Ref: 4417

15 December 2016

RE: Review of Vegetation Management Plans for Gregory Hills Corporate Park Riparian Corridor

Figure 1 Management Zones and Treatments – Source VMP February 2015

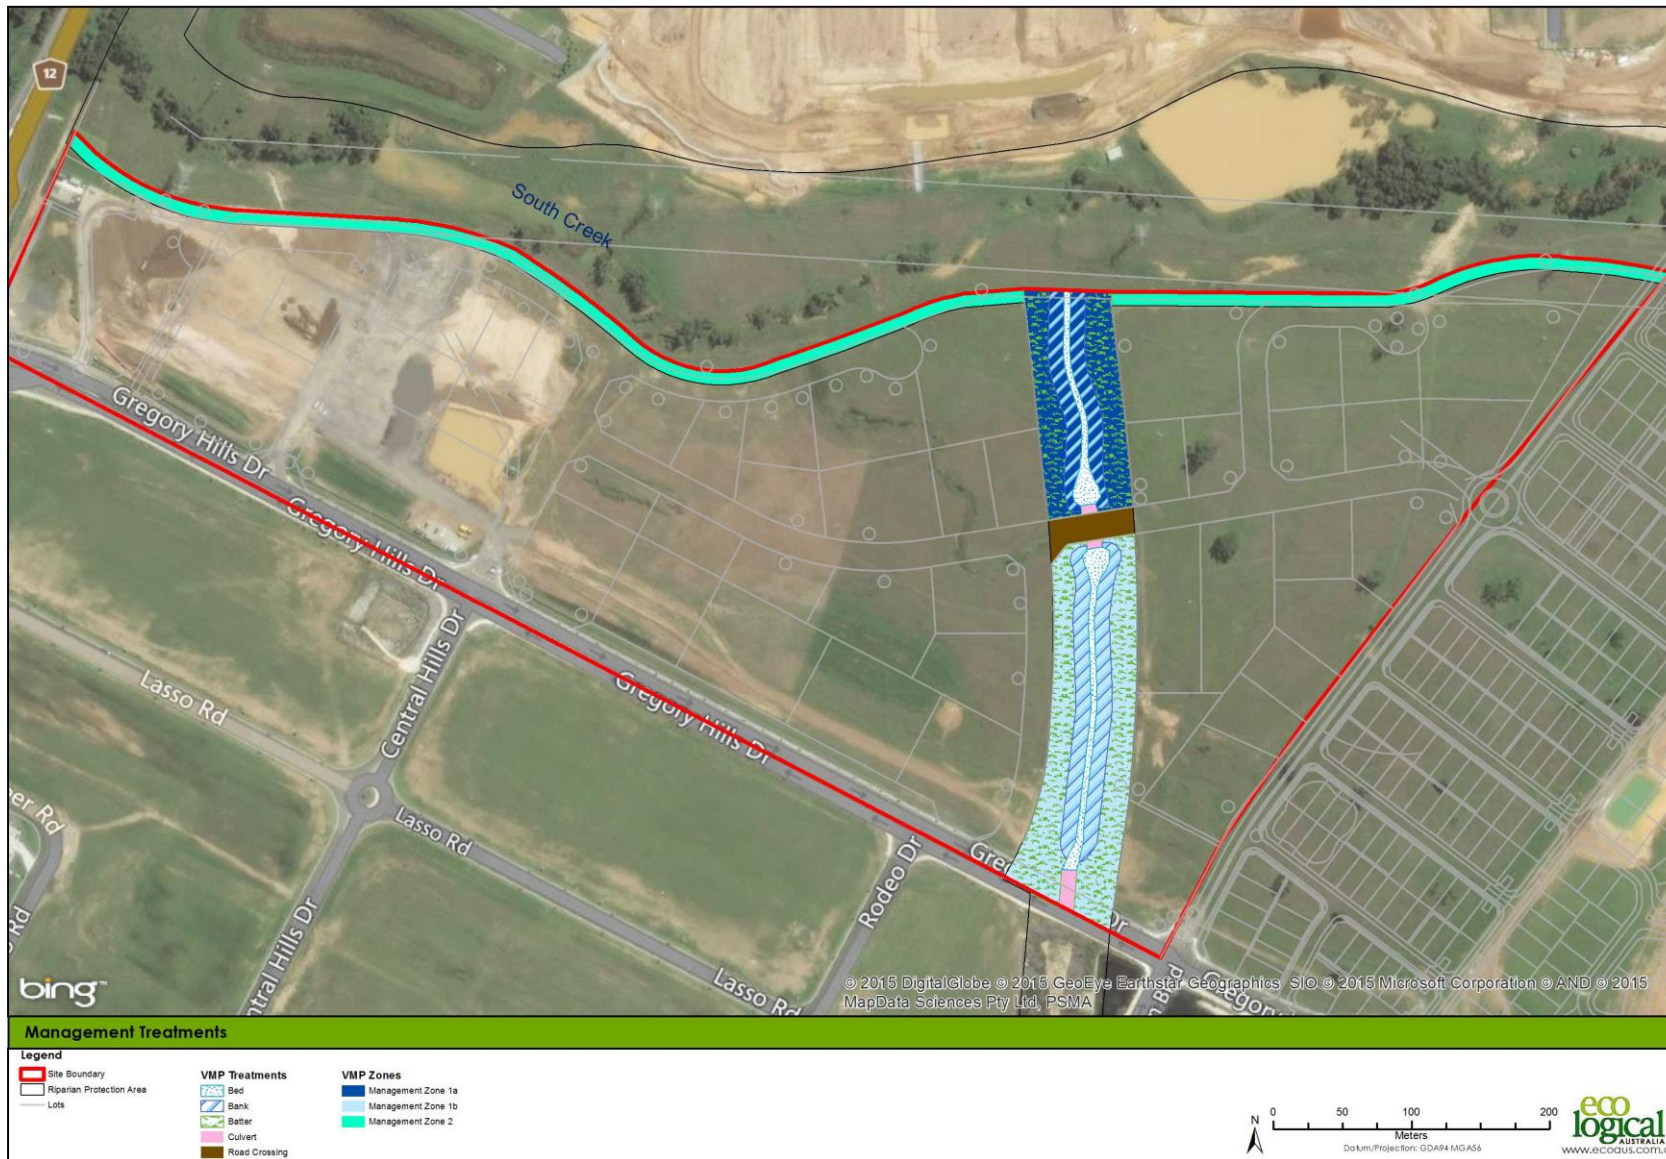
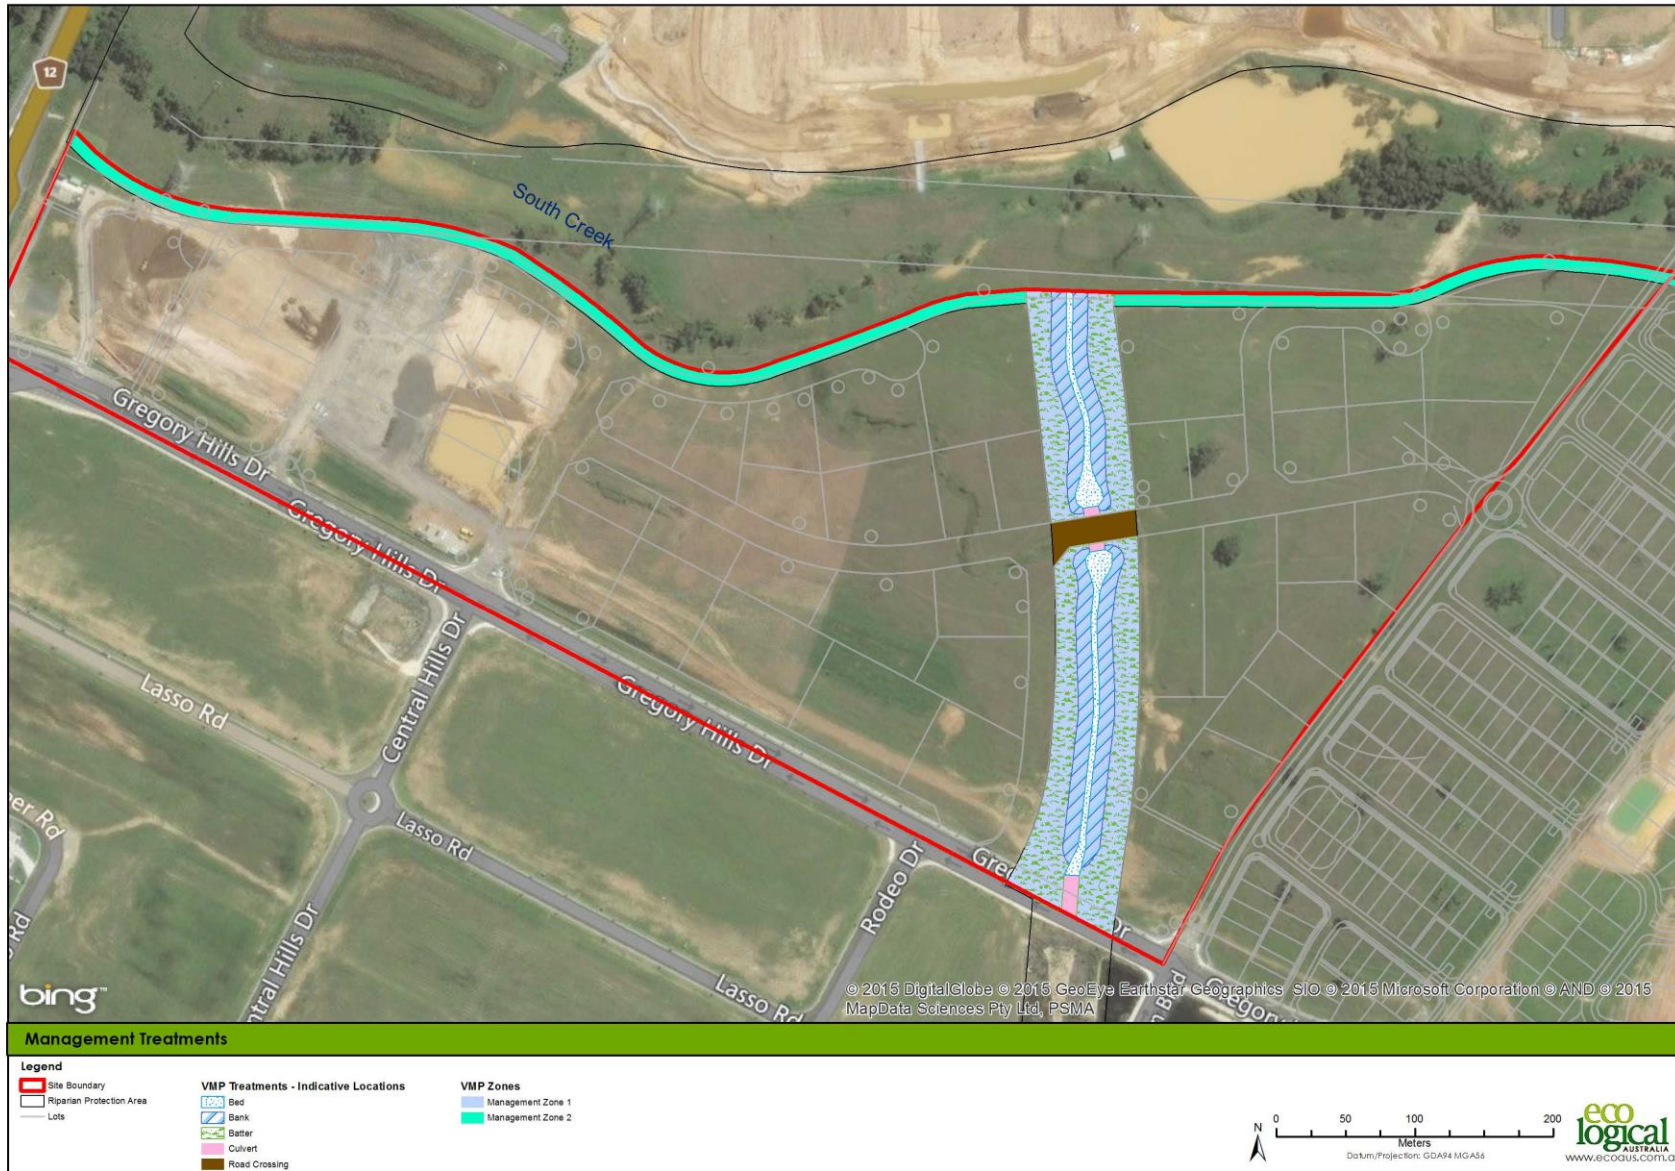
The key difference between the February 2015 VMP and the November 2015 is the location of the Management Zones within the riparian corridor.

The February 2015 VMP has Management Zone 1a (north of Digitaria Drive) and 1b (South of Digitaria Drive). **Figure 1** shows the location of the management zones in the February 2015 VMP. Specifically Management zone 1a was proposed to be revegetated to a fully structured River Flat Eucalypt Forest vegetation community. Management zone 1b, whilst still to be planted out with the same species as 1a, the planting design and densities were to be modified so that the future riparian corridor would not pose a bushfire threat to the surrounding development. Management zone 1b was to be a more open vegetation structure than that of zone 1a. This would mean that the revegetated riparian corridor north of Digitaria Drive (1a) would create a future hazard to the surrounding lots.

The November 2015 VMP included the amendment of the 2 previous zones 1a and 1b into one singular management zone as shown in **Figure 2**. The management treatments were subsequently changed to specify revegetation of the entire corridor to a River Flat Eucalypt Forest vegetation community. However, the planting design and densities were to be modified so that the future riparian corridor would not pose a bushfire threat to the surrounding development. This would mean that, if the VMP requirements for the planting densities and maintenance were complied with then the entire corridor would not pose a future hazard to the surrounding lots.

Specifically, the revegetation of the banks and batters, the following additional planting regimes would be required in order to create a vegetation community which will not pose a future bushfire hazard;

- Trees should be planted to allow a crown separation of 2-5m at maturity. Tree canopy cover should not exceed 15%
- Shrub and sedge plantings should be designed as clumps or islands and should not covering more than 20% of the area.

Figure 3 General Arrangement Plan – Source Mott MacDonald

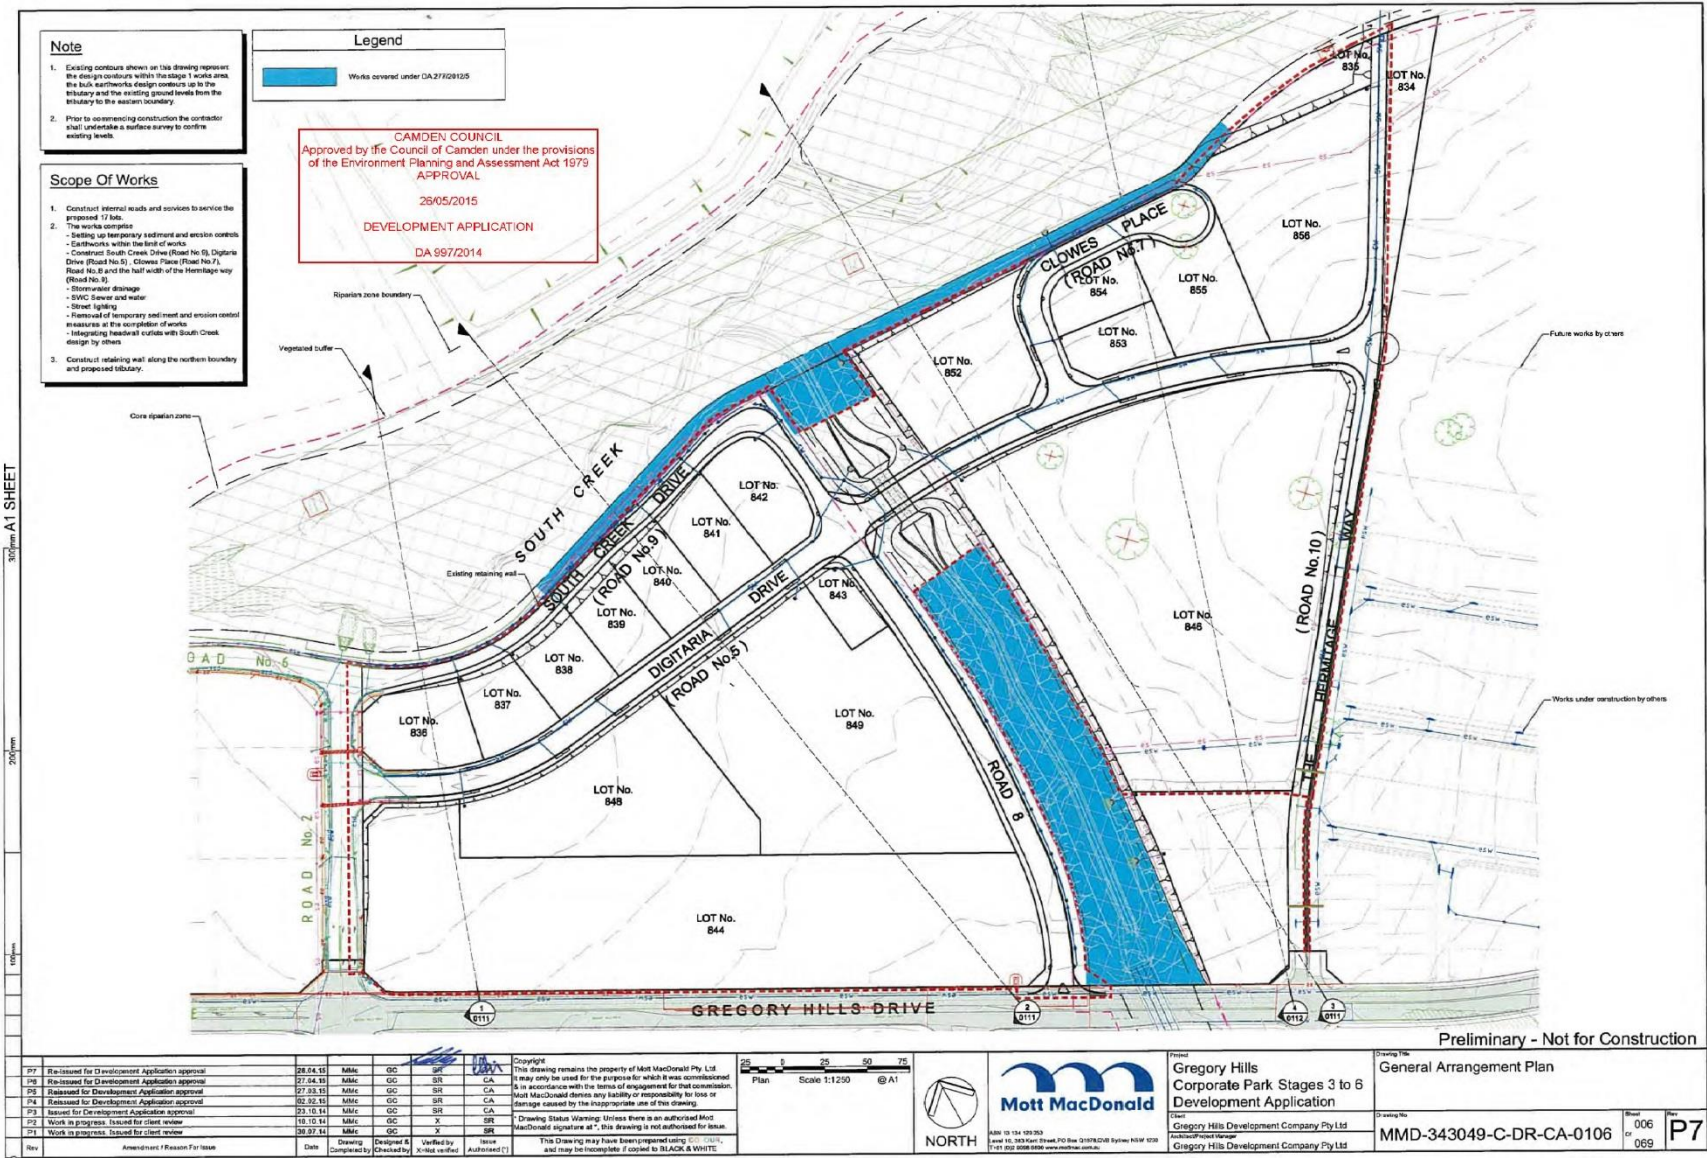
With respect to the Camden Medical Precinct SSD Development which is located in lot 846 on the stamped plans (**Figure 3**). The differences between the February 2015 VMP and the November 2015 VMP will not change the conclusions made by ELA regarding the potential bushfire hazard of the corridor adjacent to Camden Medical Precinct.
